## **Detailed Submission - New High School at Jerrabomberra (SSD-24461956) Objection to Proposal**

# **Submission and Comments from Council on Jerrabomberra High School - SSD-24461956**

Council's Ref: PR.2021.1044  
DPIE Ref: SSD-24461956  
Council Contact: M J Thompson  
[Council@qprc.nsw.gov.au](mailto:Council@qprc.nsw.gov.au)

## Services Plans (not WAE) – 300 Lanyon Drive (to become 101 Enviroana Drive) Jerrabomberra

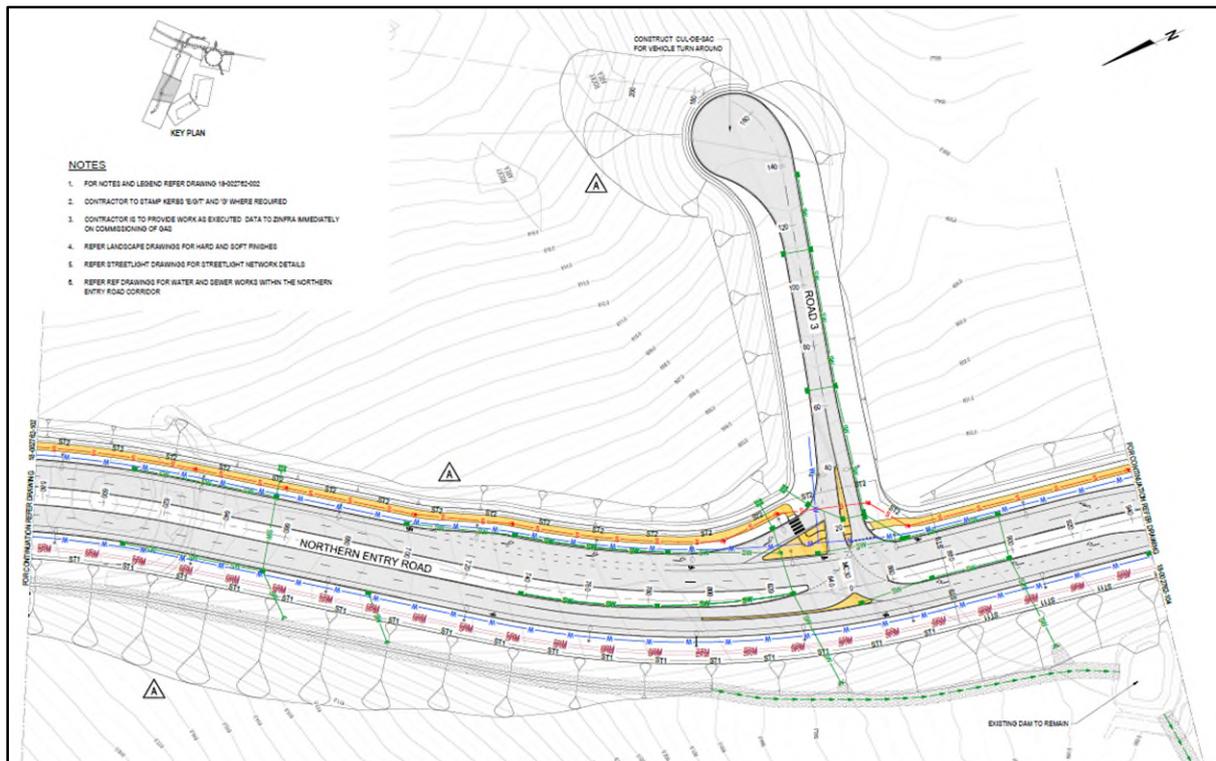
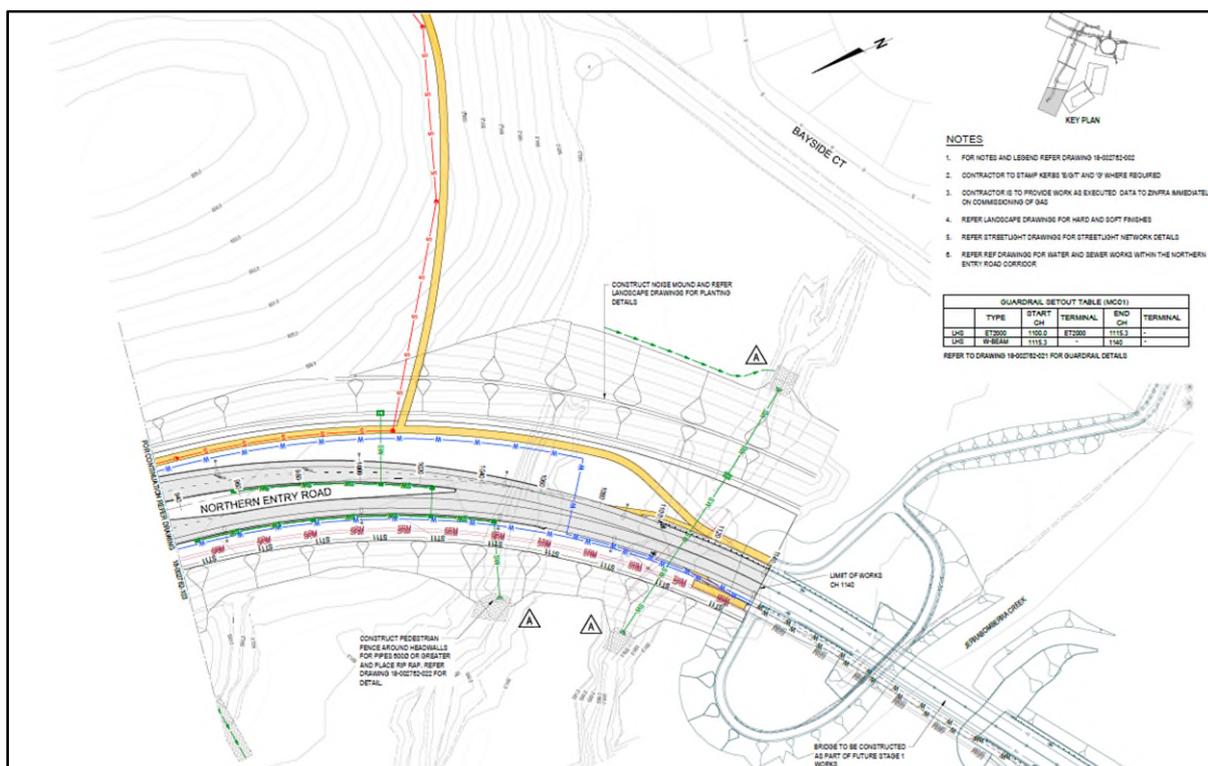
The main Council facilities impacted by the development are shown in the extract image below.

The high school development site is within the Jerrabomberra pressure zone and has connectivity to recently constructed 300mmØ DICL potable water main in the eastern verge of Enviroana Drive and northern verge of the north road, associated with the Enviroana Drive project in 2021.

The high school development site will be serviced by a recently constructed 225mmØ PVC local sewer main in the eastern verge of Enviroana Drive, associated with the Enviroana Drive project in 2021.

Figure 4 in the plan shows sewer connection to manhole S112 near the Bus Zone. The sewer connection should be through a standard connection to the sewer main running towards the rear of the school block.

The high school development site can be serviced by a storm water connection to the recently constructed pit (G02) adjacent to the Bus Lane with a 600mmØ RCP drainage pipe connecting to the new infrastructure line in Environa Drive.

The proposed development of the site will increase runoff, thus a stormwater management plan demonstrating the proposed development will not exceed pre-development runoff flow for both 20% and 1% storm events is required in accordance with Council's D5 Stormwater Drainage Design specification, and water quality in accordance with Council's D7 Erosion Control and Stormwater Management Design specification and corresponding computer modelling.

The provided civil plans support the construction of an on-site detention (OSD) tank to accept stormwater from impermeable areas, which is a necessary requirement for this development.

- Preparation of a hydraulic design plan providing details of the required sizing for all water, sewer and stormwater services required for the site.
- The preparation of an on site detention design to limit stormwater discharge from the site to pre-development flows.
- That all connections and alterations to Council's utility services are inspected by Council staff prior to backfilling.

## 1% AEP Pre and Post Development – 101 Environa Drive, Jerrabomberra

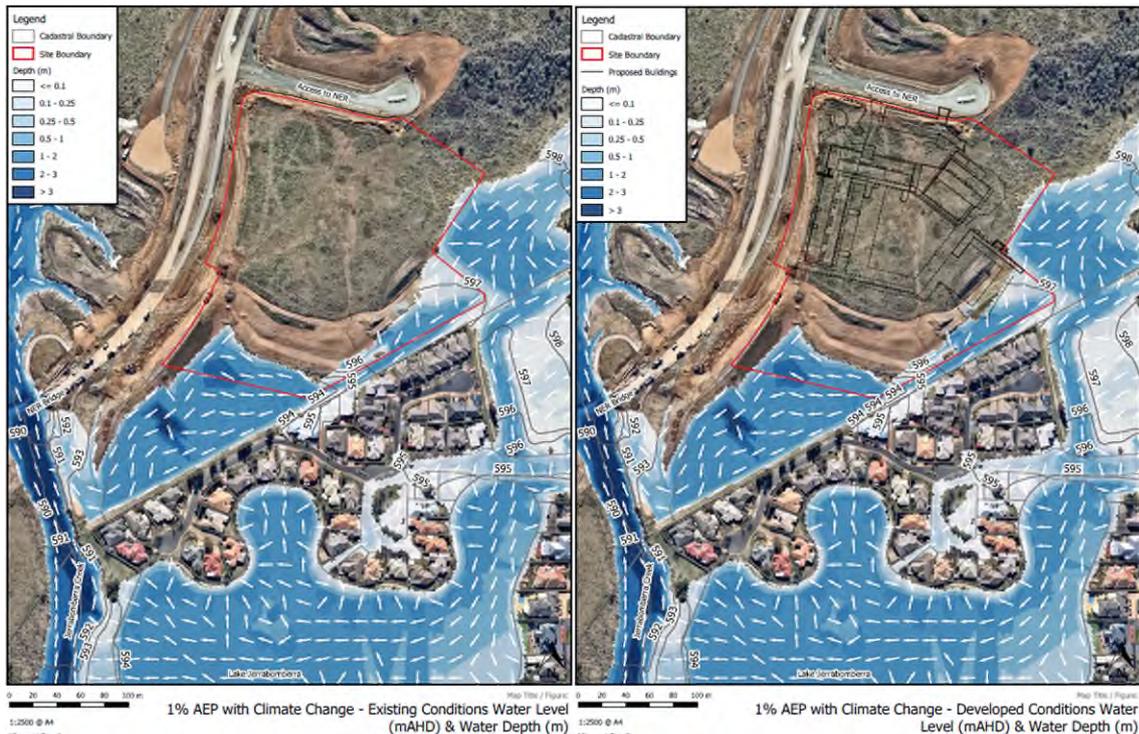
DRAINS software package was used with the RAFTS hydrological engine to assess the 1% AEP flood with and without climate change, and probable maximum flood (PMF) peak flow rates for a range of storm durations between 10 minutes and 6 hours.

The critical storm duration for the site was determined to be 1 hour for the 1% AEP flood event with and without climate change. For validation purpose, a 6 hours 1% AEP flood is modelled for the critical storm duration in the Jerrabomberra Creek upstream of the recently constructed NER 1 bridge. As the site is affected by the mainstream flooding during the PMF event, the critical storm duration of 3 hours for the Jerrabomberra Creek was adopted for the flood assessment modelling.

- Flood characteristics are consistent with existing conditions, and differences due to the proposed high school development are negligible.
- Flooding on the school site is limited to lower areas for the 1% AEP and PMF events. All school building finished floor levels are above the PMF level.
- The proposed buildings are outside of flood extent in the 1% AEP with and without climate change, and PMF events.
- All building finished floor levels are above the FPL and PMF levels.

Nil.
